STAFF REPORT

APPLICATION
RZ/FDP 2015-HM-011
Concurrent with SEA 94-H-049

APPLICANT: CESC Commerce Executive Park, L.L.C.

CONCEPTUAL DEVELOPMENT PLAN FINAL DEVELOPMENT PLAN SPECIAL EXCEPTION AMENDMENT

Figure 3: Pedestrian and Bicycle Connectivity

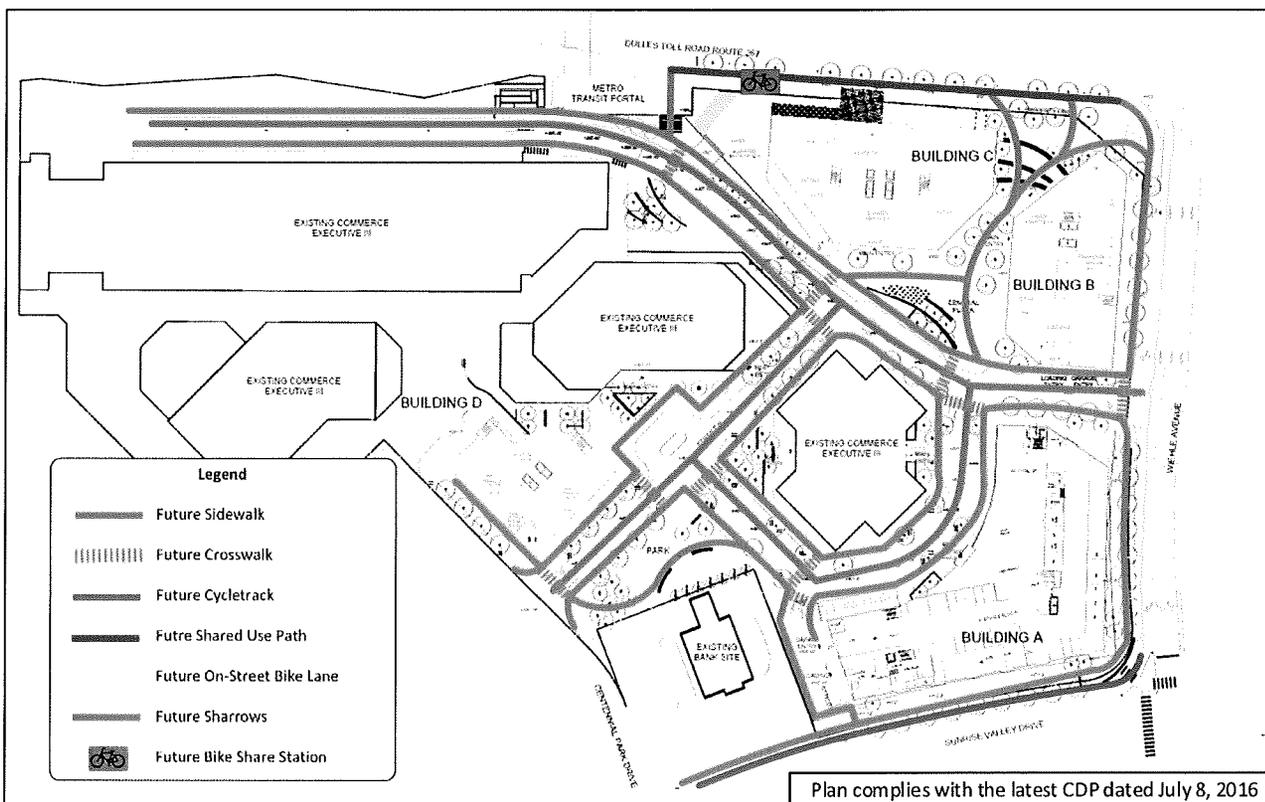
Response: Text regarding the changes to transit once Phase 2 of the Silver Line opens has been added to the study. (Page 2)
- 3. Figure 3 (Pedestrian and Bicycle Connectivity):** Recommend this Figure be either upgraded or reference that the final plan may have differences between what is shown in this graphic versus what gets approved for the zoning case.

Response: Figure 3 has been updated to reflect what is being approved for the zoning case. (Page 4)
- 4. Future Bicycle Improvements:** Staff inquired about a commitment to provide a future bike share station based on the varying language in this section versus the language in the conclusions. In the most recent copy of proffers staff reviewed a bike share station was not discussed.
